RE: Slim Chicken
8240 Montgomery Blvd NE
Grading and Drainage Plans
Engineer's Stamp Date: 07/05/21
Hydrology File: G19D004E

Based upon the information provided in your resubmittal received 07/05/2022, the Grading & Drainage Plan is **not** approved for Building Permit and for action by the DRB on Site Plan for Building Permit. The following comments need to be addressed for approval of the above referenced project:

SLIM CHICKEN 8240 MONTGOMERY BLVD NE	DRAWN BY pm
	GRADING AND DRAINAGE PLAN	DATE 7-5-22
		DRAWING 2021089-GR
		SHEET #
		GR-1
		JOB # 2021089

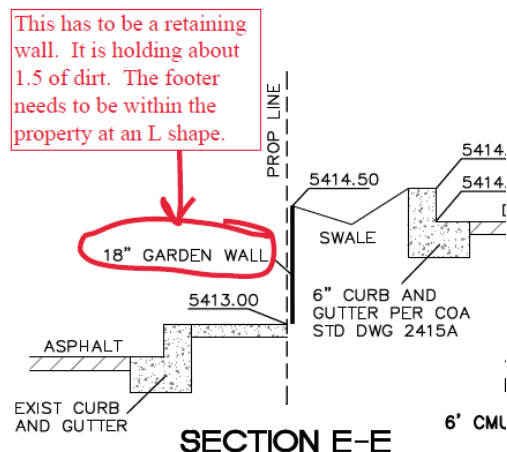
1. The retaining wall along Montgomery needs to be labeled as such in Section E-E. This also needs to show an L shaped footer within the property.

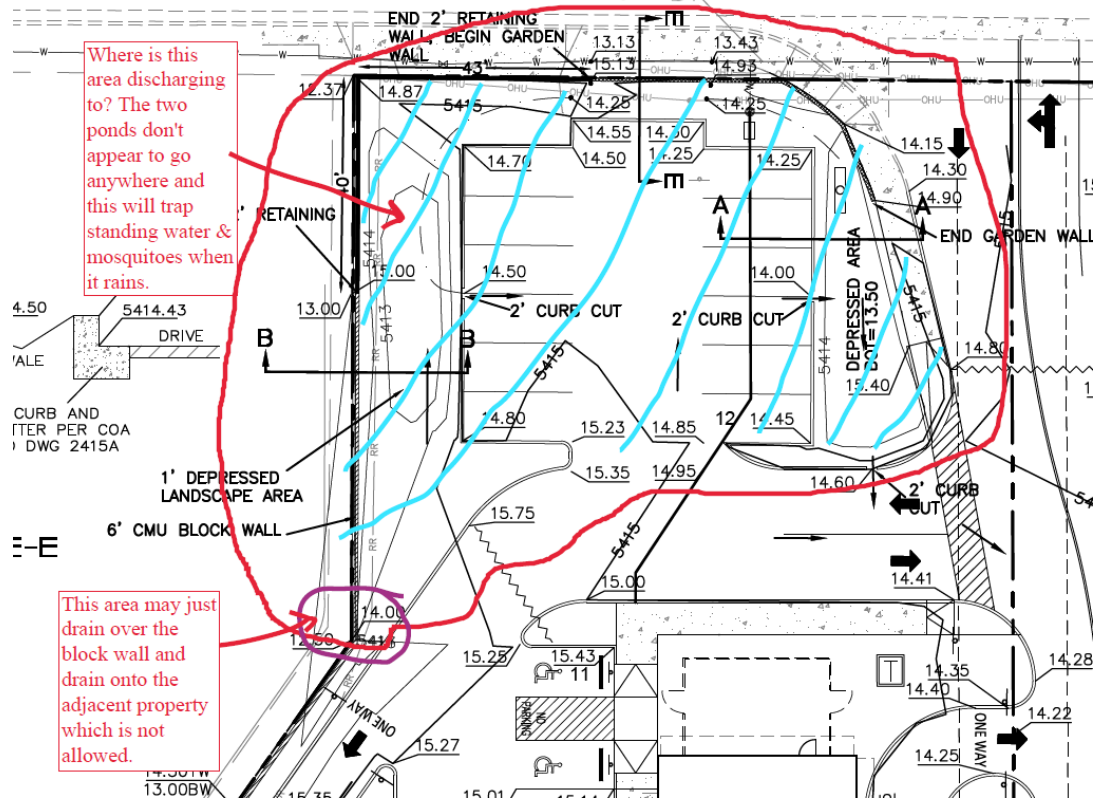
2. There is still issues with the whole parking area by Montgomery drainage. Where is this area discharging to? The two ponds don't appear to go anywhere and this will trap standing water & mosquitoes when it rains. This area may just drain over the block wall to the southwest and drain onto the adjacent property which is not allowed. Another

issue is that the depressed areas are not needed since this Tract is covered by the overall development's Stormwater Quality Pond to the south next to La Mirada Place.

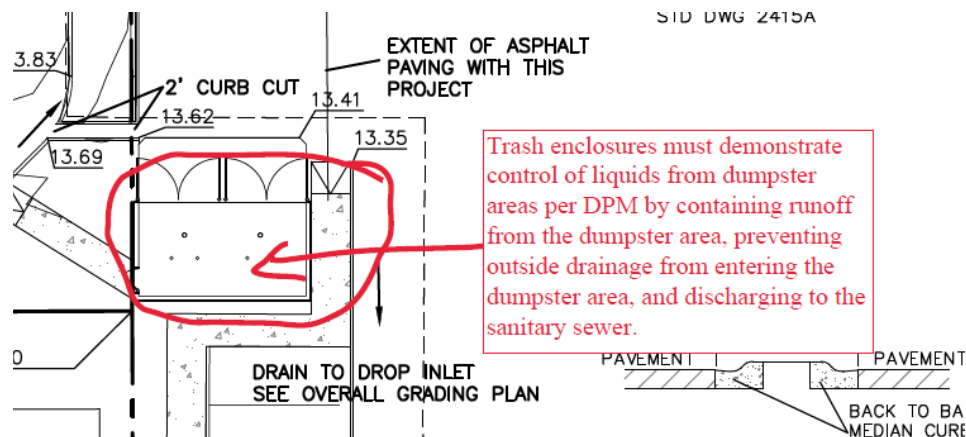
- Trash enclosures must demonstrate control of liquids from dumpster areas per DPM by containing runoff from the dumpster area, preventing outside drainage from entering the dumpster area, and discharging to the sanitary sewer. Please show an inlet in the middle and label. "Inlet to be connected to the sanitary sewer. See Utility Plan."

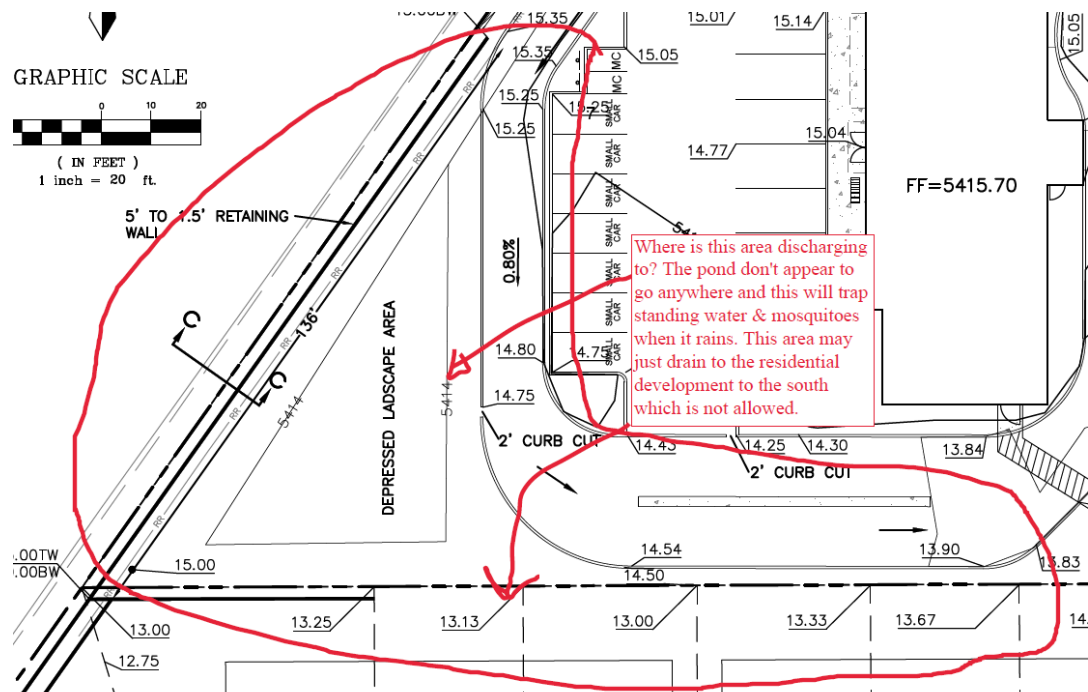
- The low area in the Southwest corner has some drainage issues. Where is this area discharging to? The pond doesn't appear to go anywhere and this will trap standing water & mosquitoes when it rains. This area may just drain to the residential development to the south which is not allowed. Again there is an issue is that the depressed area which is not needed since this Tract is covered by the overall development's Stormwater Quality Pond to the south next to La Mirada Place.
